**RE: Natick Avenue Solar Development
Cranston, Rhode Island**

On behalf of the applicant, Natick Solar, LLC, we respectfully submit this project narrative with our Preliminary Submission per Section III (J)(3)(d)(7) of the City of Cranston Subdivision Regulations. The site is located west of Natick Avenue and has an existing drive that provides access to the property. The owner of the property is Ronald Rossi (Assessor's Plat 22-3 Lots 108 and 119). The site has a total area of approximately 64 Acres and is zoned A-80.

Photo Locations

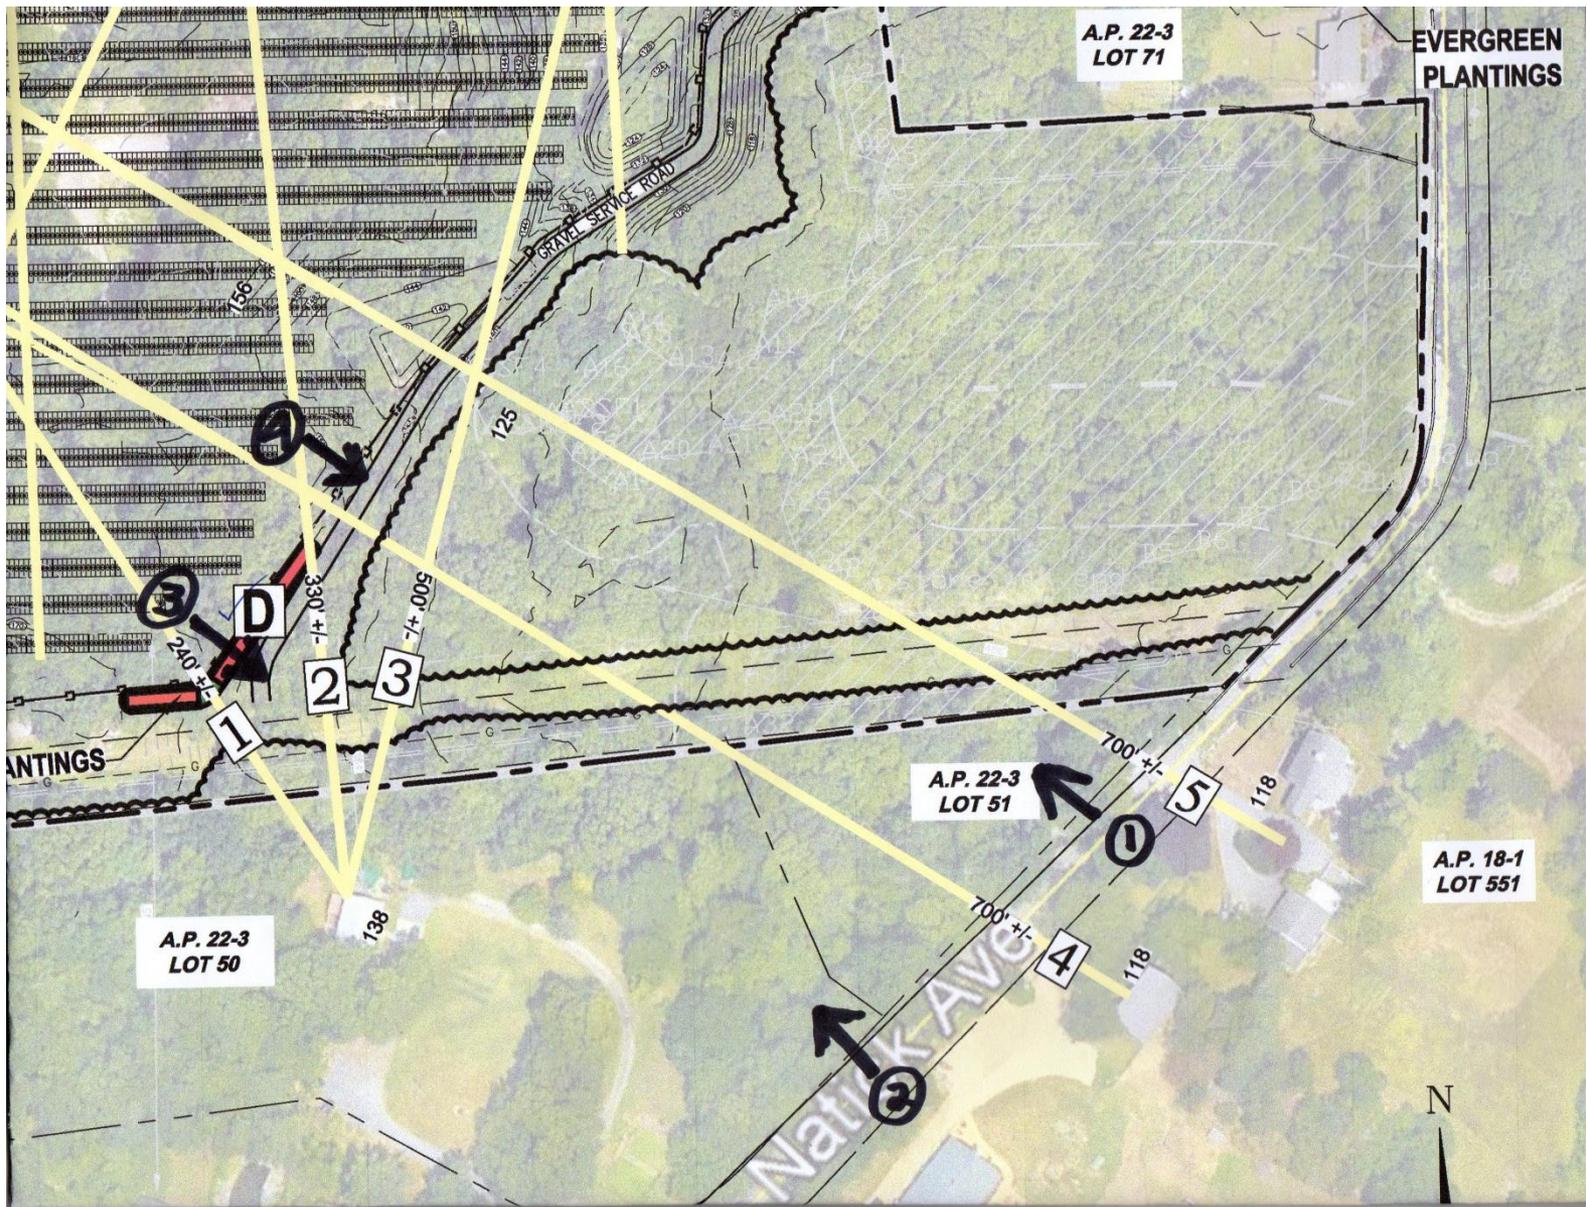
- **The last divergence is a suggestion to plant more trees along the eastern edge of the service road near the gas easement to screen the view from Natick Avenue. For the same reason in 'D' above, there is substantial vegetation between Natick Avenue and the proposed solar field this time of year as shown in the attached photos during the winter conditions with no leaves on the trees. Photographs and additional detail has been provided in this letter.**
